<b>REPORT TO</b>	Statutory Planning Committee		
<b>Meeting date</b>	20 November 2018	<b>File number</b>	156906
<b>Subject</b>	Subdivision to Create 1,940 Lots and 17 Reserves - Various Lots Barragoon Road, Caraban, Moore River South		
<b>Purpose</b>	Requires WAPC decision		
<b>Title of Approving Officer</b>	A/Assistant Director General, Land Use Planning		
<b>Agenda Part for Reports</b> SPC - Non-Confidential (To be published to the website)			
<b>SITE-SPECIFIC DETAILS</b>			
<b>Region/s</b>	Wheatbelt		
<b>Local government/s</b>	Shire of Gingin		
<b>Landowner: Consultant:</b>	Moore River Company Pty Ltd - Marcus Plunkett & Graeme Sampson Creative Design + Planning - Denise Morgan & Chee Mok		
<b>Location map</b>	Attachment 1 - Locality plan		
<b>Bushfire Prone Area</b>	YES		
<b>Statutory Planning Committee</b>			
<b>Local Scheme Zoning</b>	Future Development and General Rural		
<b>Council's recommendations</b>	Approve subject to conditions

<b>Receipt date</b>	29 June 2018	<b>Process days</b>	144 (with deferral)
<b>Property Address</b>	Lots 2593, 3156, 2802, 2914, 2424 and 3099 Barragoon Road, Caraban		
<b>SUMMARY</b>			
<p>The application proposes the subdivision of Lots 2424, 291

A 28 Brown Street, East Perth WA 6004

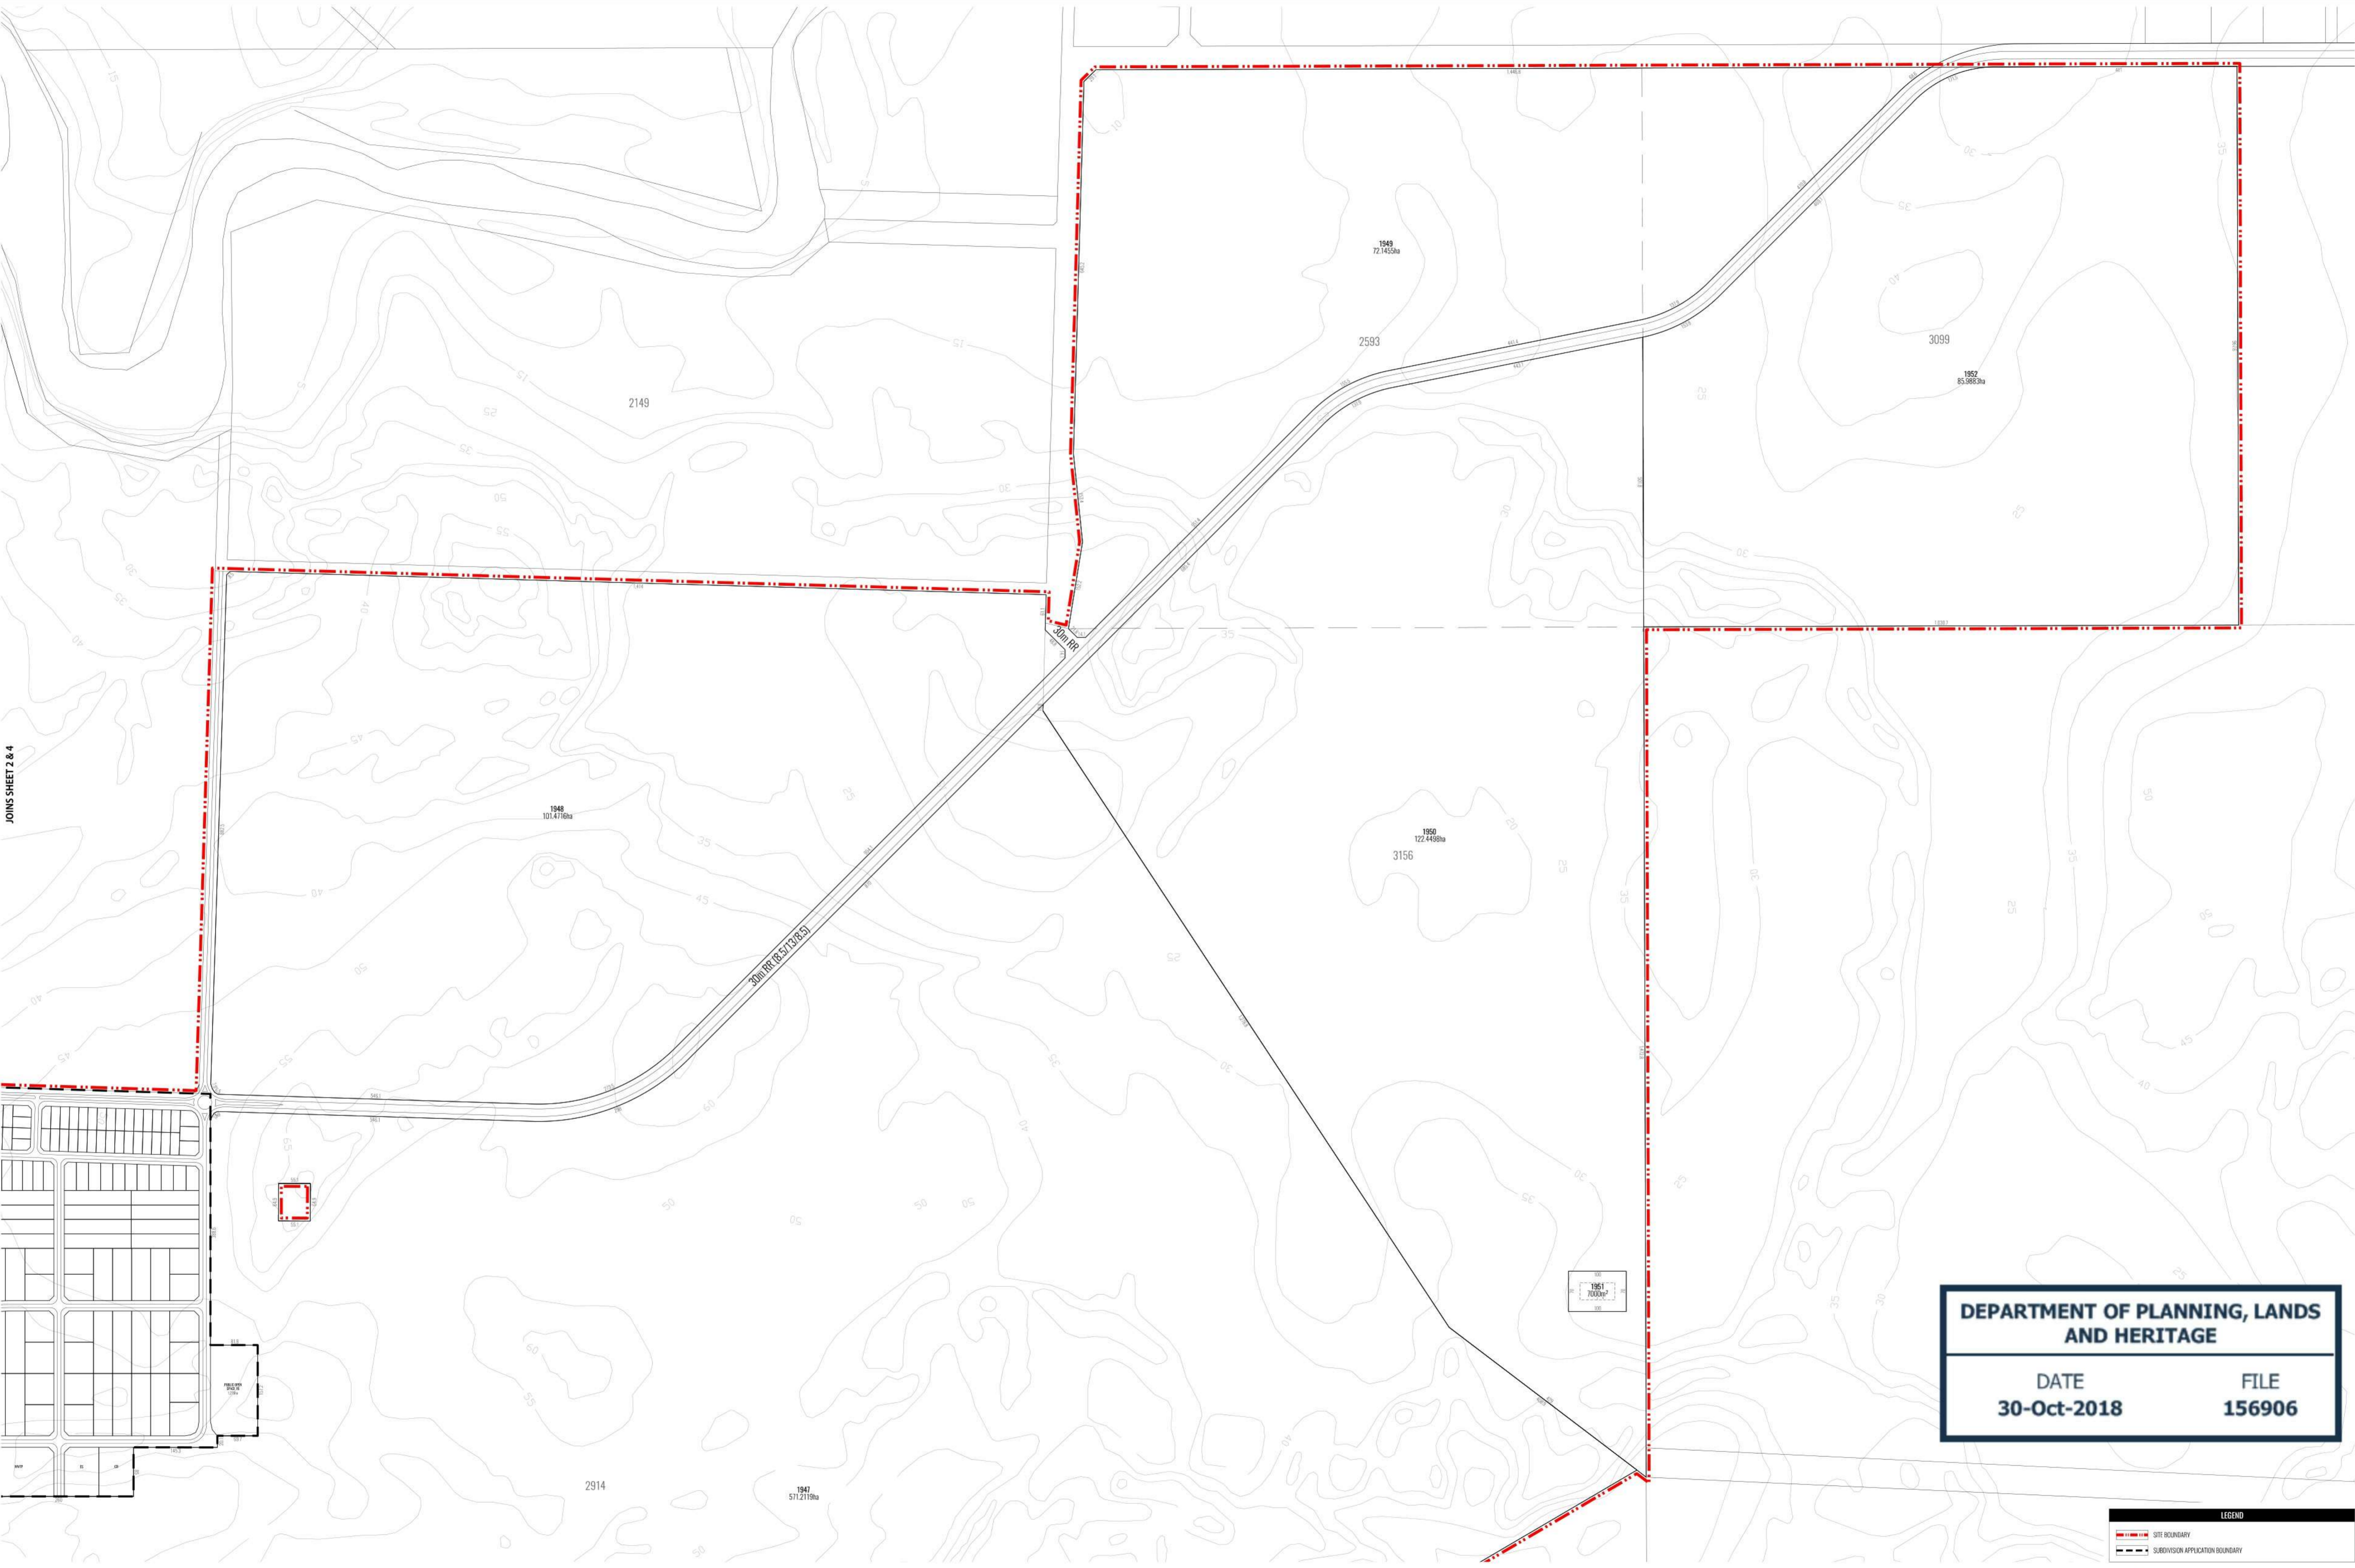
Concerns regarding road hierarchy, access onto Indian Ocean Drive and the size of the primary school site were raised through the referral process. The applicant has submitted a modified subdivision plan dated 30 October 2018 (**Attachment 2**) and supporting information to respond to referral advice and State policy requirements.

Modifications to the plan have included lot reconfiguration to allow for widening of the foreshore reserve, a primary school site sufficient to accommodate future needs, the addition of a site containing significant tree habitat as a conservation reserve, the addition of public open space reserves (3), the addition of infrastructure lots for sewerage and groundwater services (4) and the alteration of road reserves to accommodate suitable road widths and truncations. This has resulted in the addition of 13 residential lots, 1 town centre lot and 1 tourism lot, the amalgamation of two rural lots and the removal of 4 mixed business lots.

- 1. The plan of subdivision is to be modified in accordance with the attached plan dated 30 October 2018 (Attachment 2). (Western Australian Planning Commission)***

## Topography & Classified Vegetation

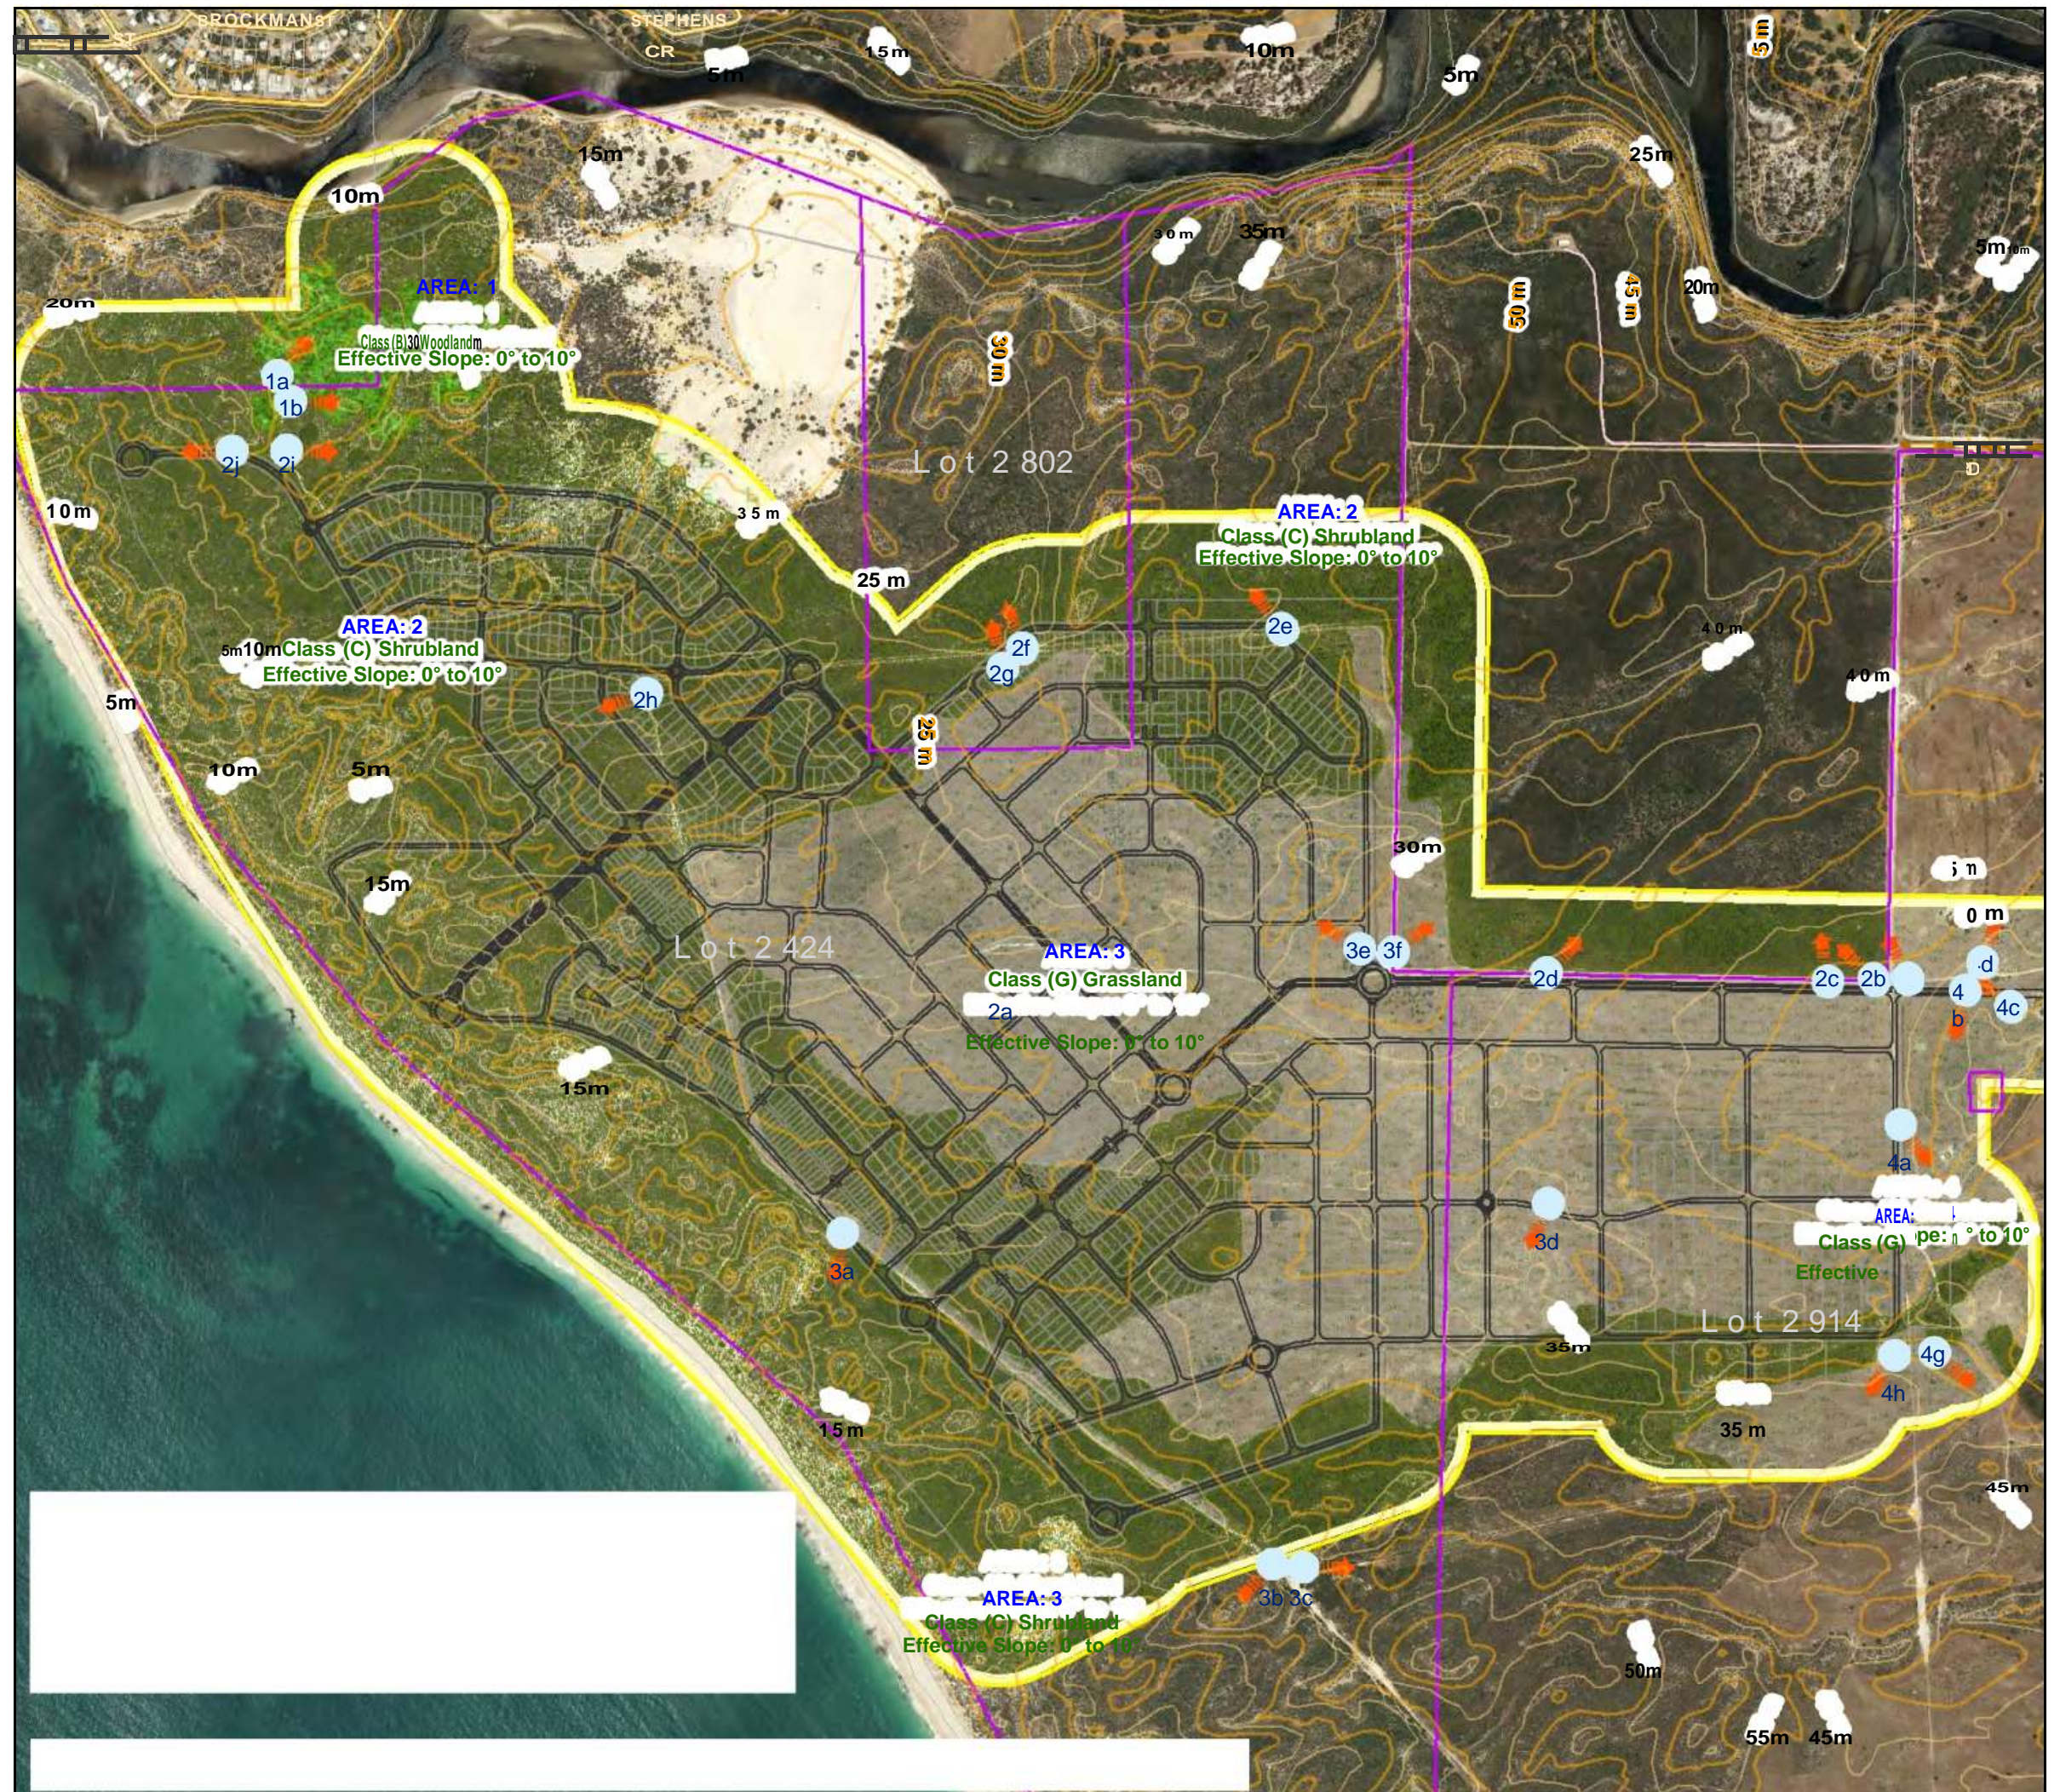
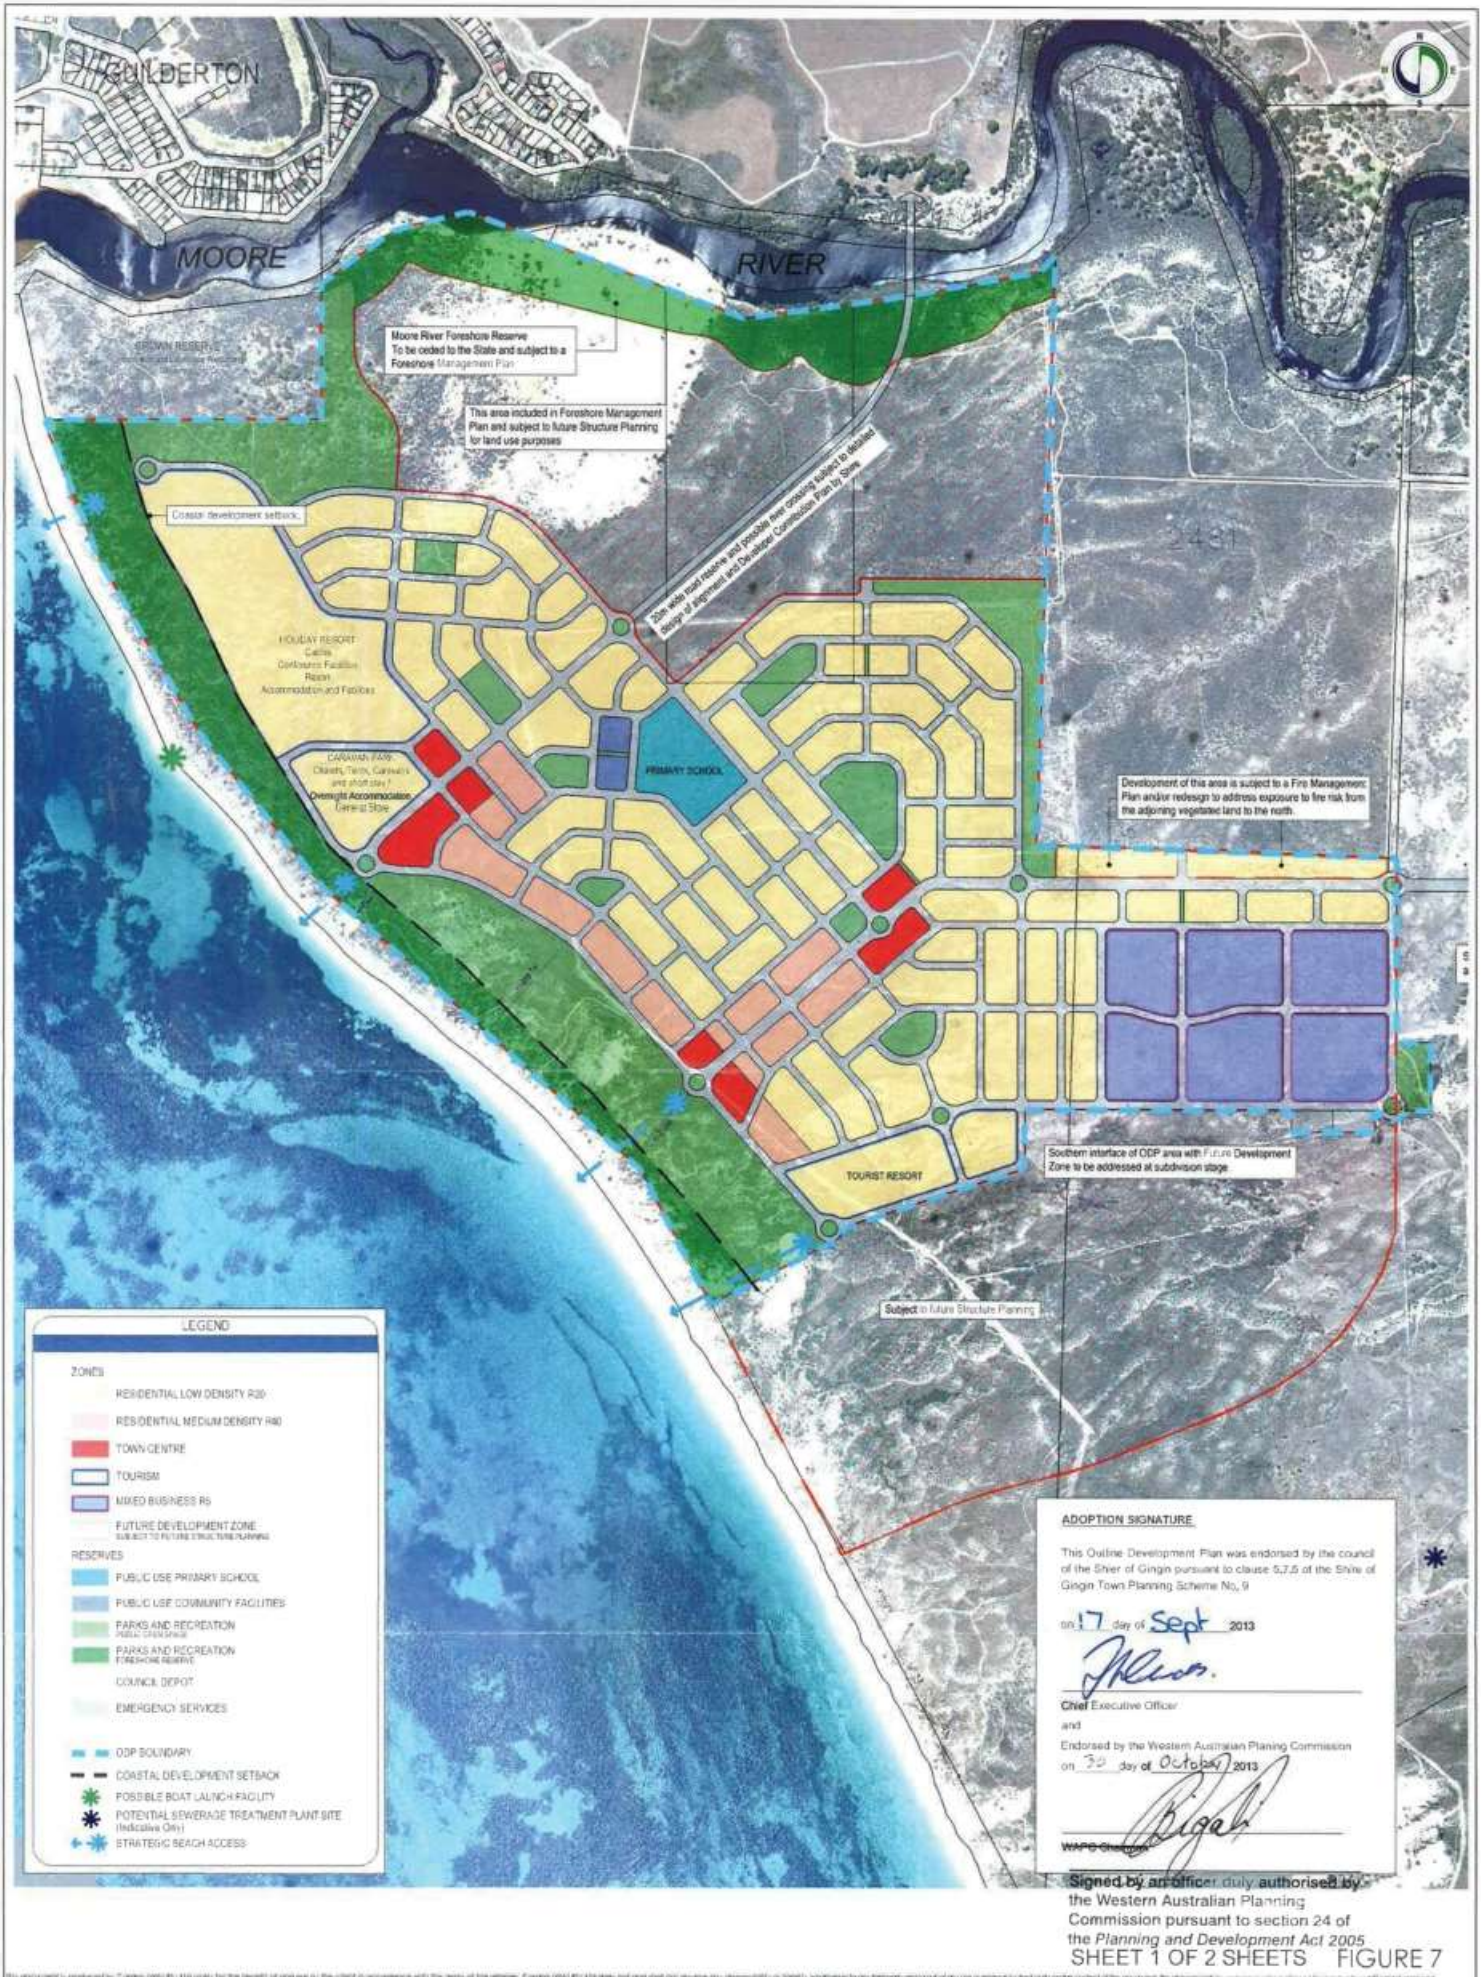
The majority of the site has been previously cleared for farming practices, however, a large portion contains significant remnant vegetation (**Attachment 3**). Zoning of the land occurred in 1995, prior to the Planning and Environment legislation being amended to require referral to the EPA. EPA provided advice to the WAPC in 1994, and this did not result in vegetated areas being removed from the zoning proposal. While in recent years there has been a greater focus on vegetation, especially that associated with Carnaby's Cockatoo habitat, at the time of this land being zoned, the vegetation and cockatoos were not known to be endangered.

- 2. Prior to the commencement of subdivisional works, measures being undertaken to confirm or deny the presence of threatened ecological communities in areas classified as Woodland or Shrubland in Attachment 3. This may include, but is not limited to, a level 2 flora and vegetation survey and/or referral under the Environmental Protection Biodiversity and Conservation Act (1999). (Western Australian Planning Commission).***
